**City of Portland, Maine – Building or Use Permit Application** 389 Congress Street, 04101, Tel: (207) 874-8703, FAX: 874-8716

Location of Construction: 752 Mariborough St.		Owner: Robert Weimer Jr.	Phone:	Permit No: 990313
Owner Address: SAA	Lessee/Buyer's Name:	Phone:	BusinessName:	
Contractor Name: Quality Design	Address: 17 Kelly Road, Falmouth, ME	Phone: 781-5405		
Past Use: 1-Family	Proposed Use: Same	<b>COST OF WORK:</b> \$ 65,000	<b>PERMIT FEE:</b> \$ 345.00	Permit Issued: APR 12 1999
		<b>FIRE DEPT.</b> <input type="checkbox"/> Approved <input type="checkbox"/> Denied	<b>INSPECTION:</b> Use Group: Type:	Zone: CBL: 06-7-020
Proposed Project Description: Build 2nd story addition		<b>PEDESTRIAN ACTIVITIES DISTRICT (P.A.D.)</b> Action: <input type="checkbox"/> Approved <input type="checkbox"/> Approved with Conditions <input type="checkbox"/> Denied Signature: _____ Date: _____		Zoning Approval: <b>Special Zone or Reviews:</b> <input type="checkbox"/> Shoreland <input type="checkbox"/> Wetland <input type="checkbox"/> Flood Zone <input type="checkbox"/> Subdivision <input type="checkbox"/> Site Plan maj <input type="checkbox"/> minor <input type="checkbox"/> mm <input type="

Job - 282 Marlborough St. Portland, Me

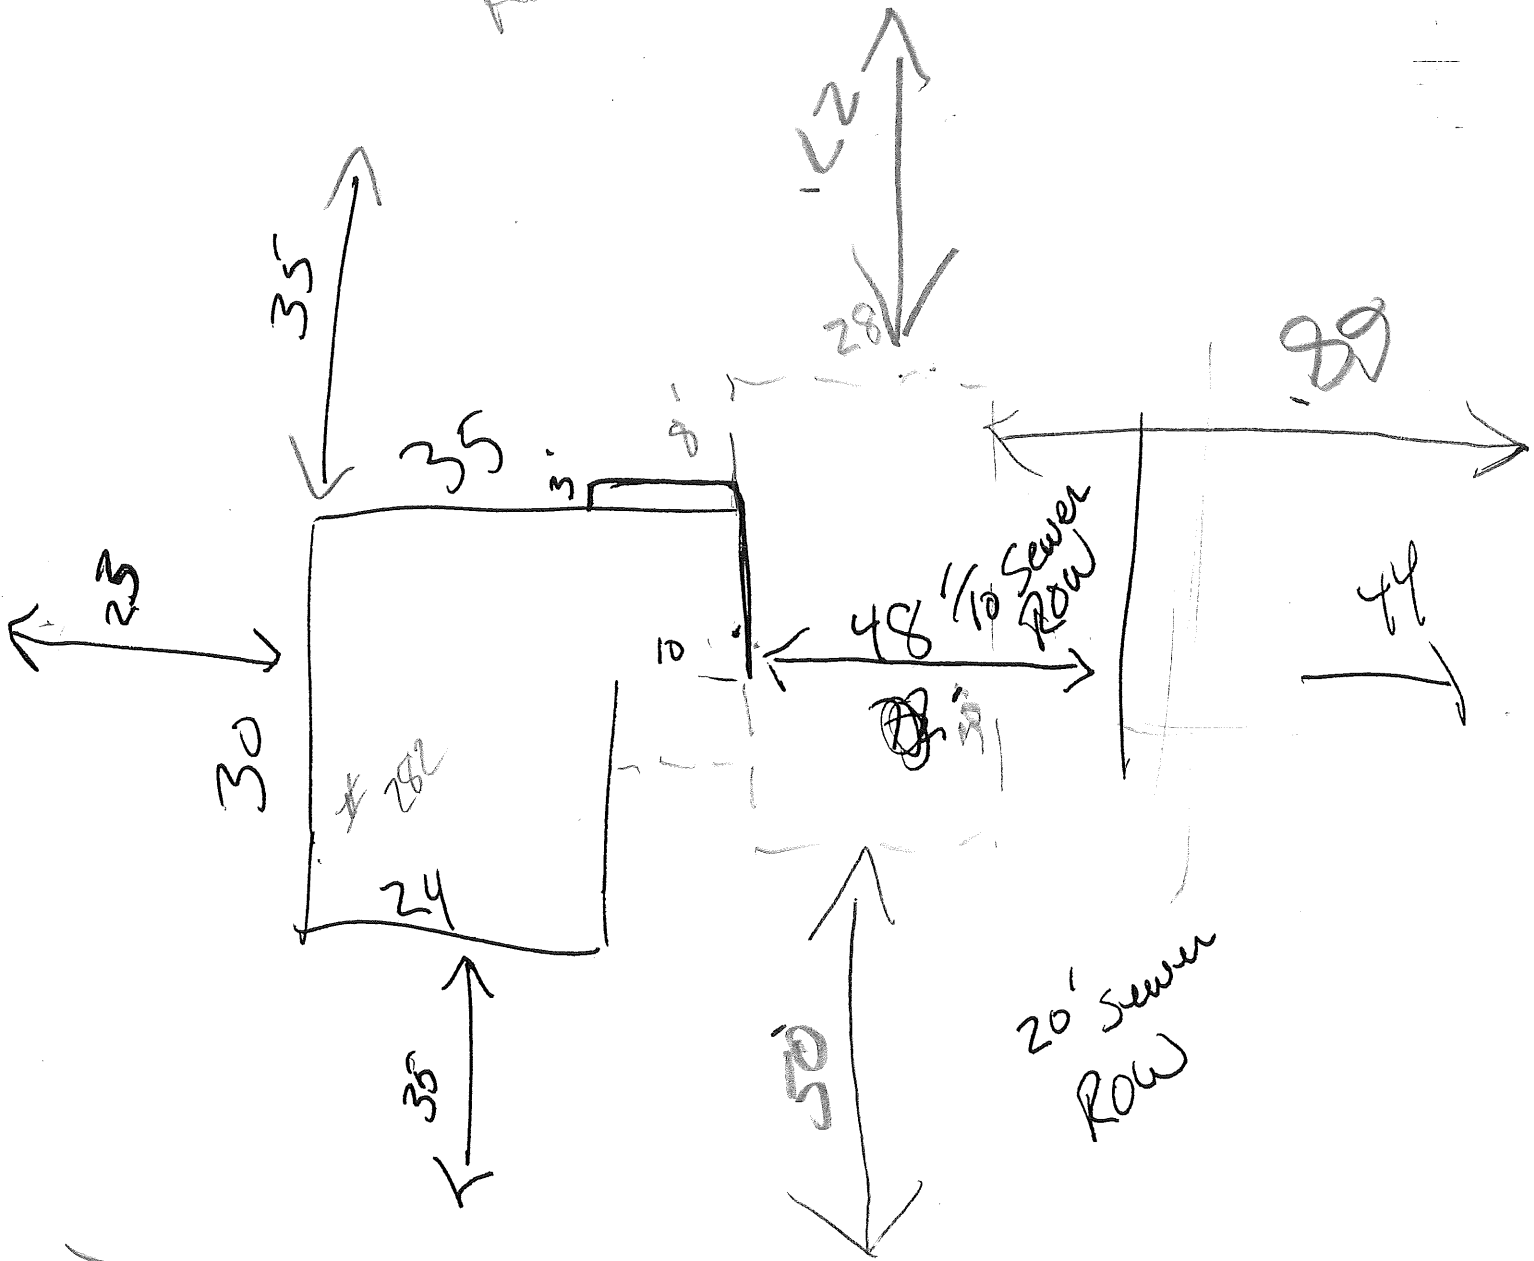
4/22/99 Meet w/ Blde. for Base Con - he will submit  
Amendment to Cover fire rating on Stairs. - also will  
Submit Design specs on J Beam & get certification from fabricator

33. Glass and glazing shall meet the requirements of Chapter 24 of the building code.
- \*34. A design of The steel beam must be submitted For approval before installation - The design must be done by a structural engineer -

Quantity Ordered	Quantity Shipped	Description	Weight*	Unit Price	Amount
		GIVEN - RESIDENTIAL AREA 1 FLOOR			
		LIVE LOAD 40"			
		DEAD LOAD 20"			
		ROOF TOTAL 70"			
		1-4' KNEE WALL			
		AREA 30' x 24'			
		BEAM LENGTH 24'			
		$\frac{30}{2} \times 24 \times 60'' = 21,600$			
		$\frac{30}{2} \times 24 \times 70'' \times \frac{4}{30} = 5,360$			
		24,960 - 24'			
		USE:			
		W 24 x 30 = 28 K - 24'			
		S <sub>y</sub> = 42 in <sup>3</sup>
